STATE OF CONNECTICUT  
CONNECTICUT SITING COUNCIL

IN RE:	:	
	:	
A PETITION OF NORTH FRANKLIN SOLAR	:	PETITION NO. 1626
ONE, LLC AND VEROGY HOLDINGS, LLC d/b/a	:	
VEROGY, LLC FOR A DECLARATORY RULING	:	
FOR THE PROPOSED CONSTRUCTION,	:	
MAINTENANCE AND OPERATION OF A 4.975	:	
MW AC SOLAR PHOTOVOLTAIC ELECTRIC	:	
GENERATING FACILITY AT 932 ROUTE 32,	:	
FRANKLIN, CONNECTICUT	:	JULY 24, 2024

**RESPONSES OF NORTH FRANKLIN SOLAR ONE, LLC  
AND VEROGY HOLDINGS, LLC D/B/A VEROGY  
TO CONNECTICUT SITING COUNCIL INTERROGATORIES**

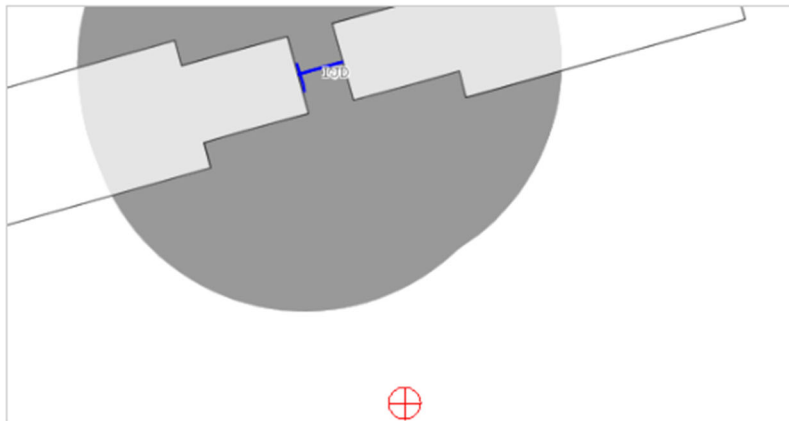
Question No. 49

Response

You do not exceed Notice Criteria.
